Agilent Automated Solder Paste Inspection System Medalist SP 3.1.6.01 Software Release Notes

Figure 1: Screenshot of Operator interface

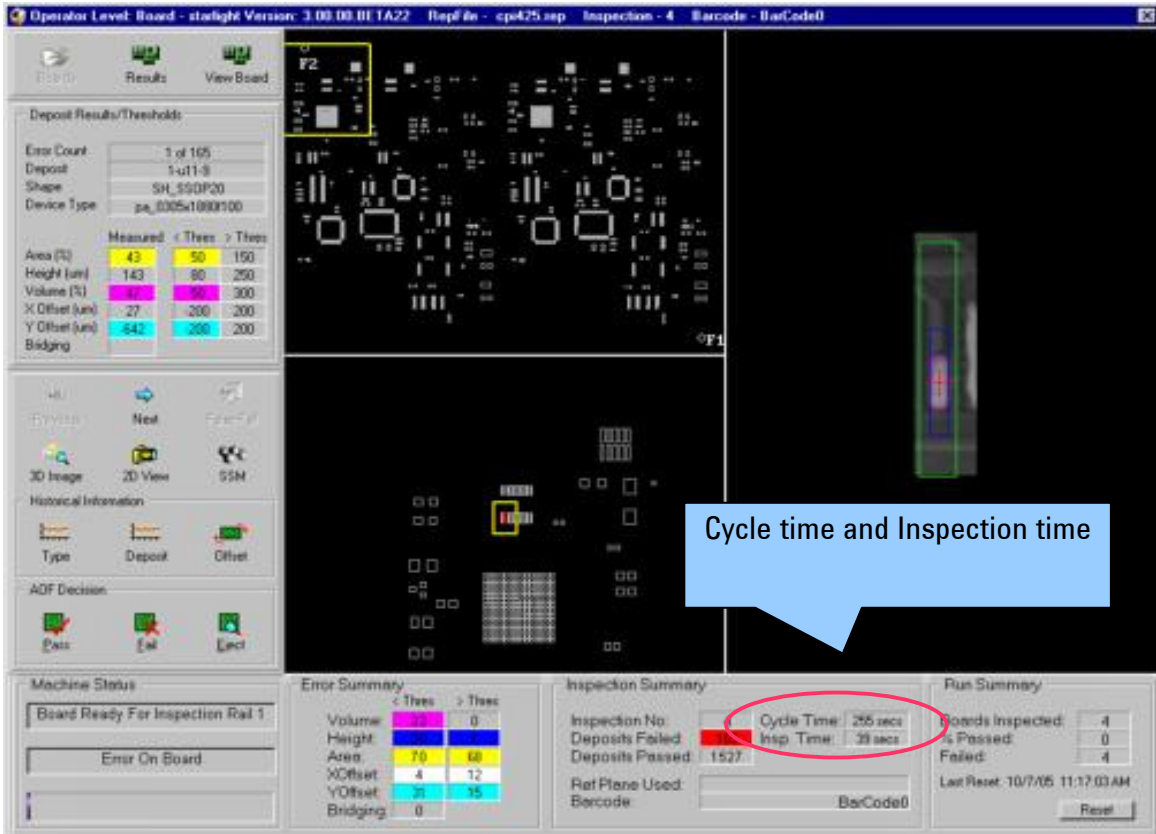
CR32643:	Operator Interface - Display Inspection Time / Cycle Time
Type:	Enhancement
Problem:	On the Operators Interface, display the inspection time and cycle time after each inspection has completed.
Resolution:	Fixed
Remark:	<p>A new PLC code update is required for this enhancement to work, please check your machine configuration below:</p> <ul style="list-style-type: none">• SP50 Series 2 and 3 standard and dual lanes machine without staging: no PLC update is required• SP50 Series 2 and 3 standard machine with staging option installed: download 5186-5794C6.swp <p>The new PLC code is located in c:\cpi\plc folder. Kindly refer to the procedure to download the PLC code, available in your Hardware manual. The inspection time and cycle time is displayed in Figure 1:</p>
